**ADDENDUM NUMBER TWO**

**USC Demolition/Renovations for Coliseum Project for Arena Level  
Project No.: U-787-14-1**

**State Permanent Improvement Project No.: H27-Z167**

DATE OF ISSUE: June 19, 2014

**AB-1**

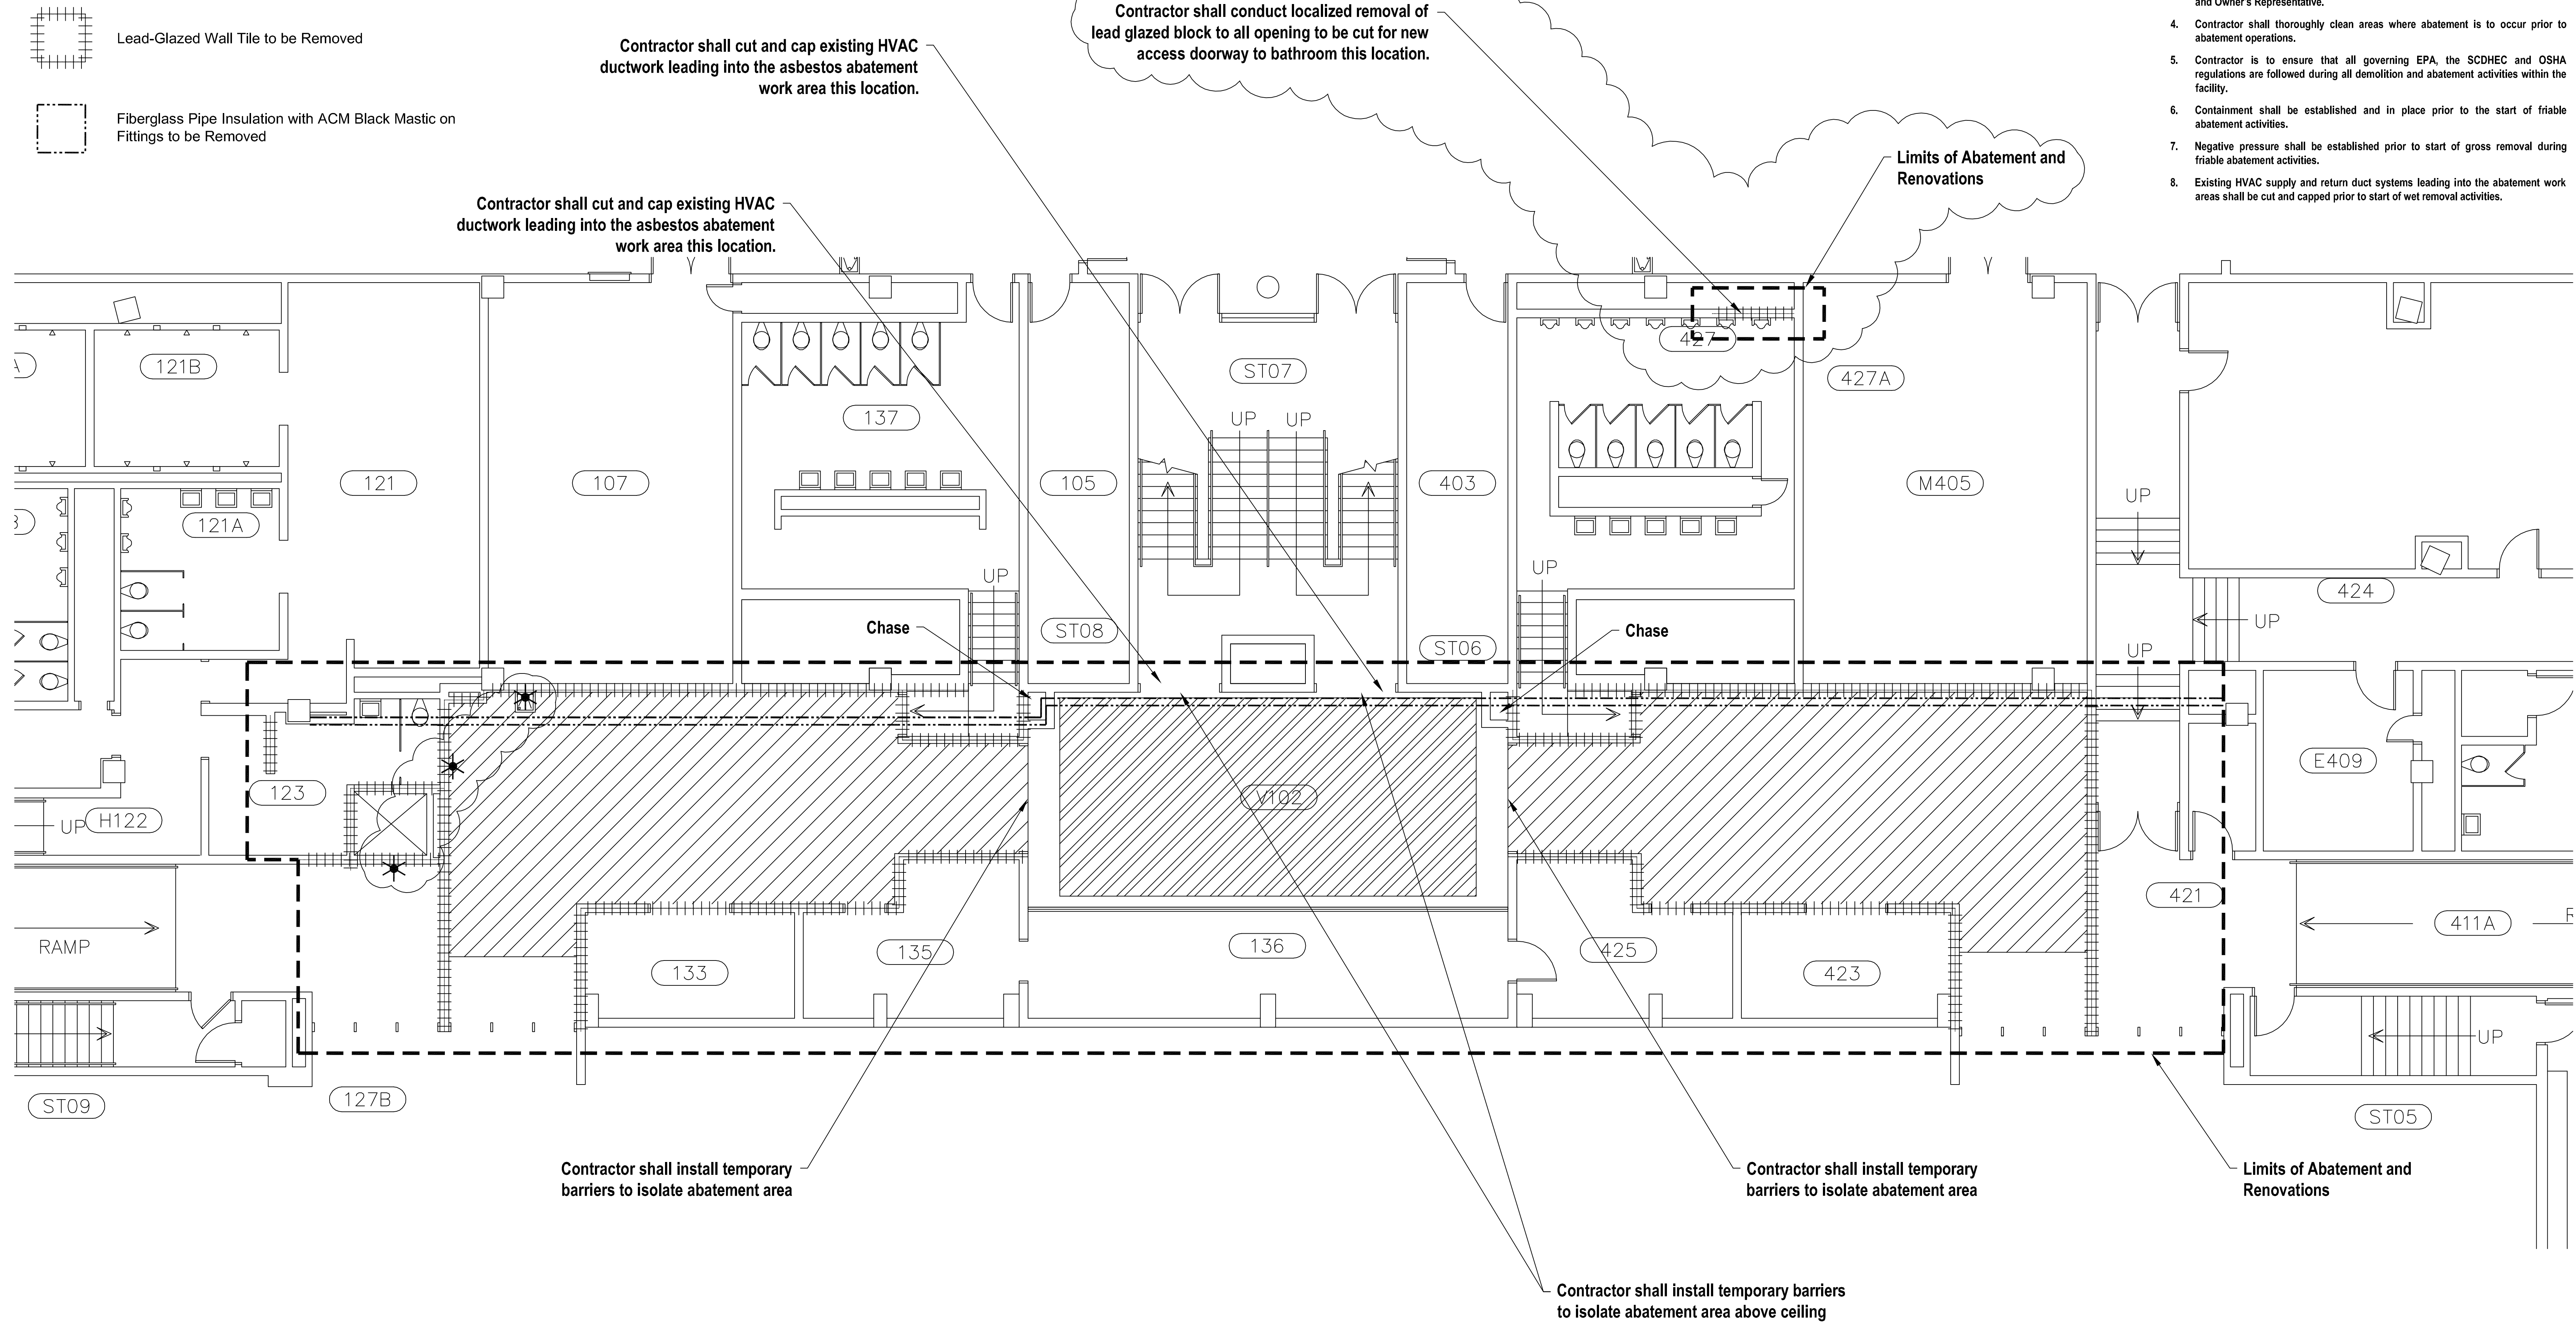
| 1. | <u>Revision:</u> Reference Drawing AB-1 for additional scope. |

Contractor shall cut and cap existing HVAC ductwork leading into the asbestos abatement work area this location.

Contractor shall conduct localized removal of lead glazed block to all opening to be cut for new access doorway to bathroom this location.

Contractor shall install temporary barriers to isolate abatement area

Contractor shall install temporary barriers to isolate abatement area

Contractor shall install temporary barriers to isolate abatement area above ceiling
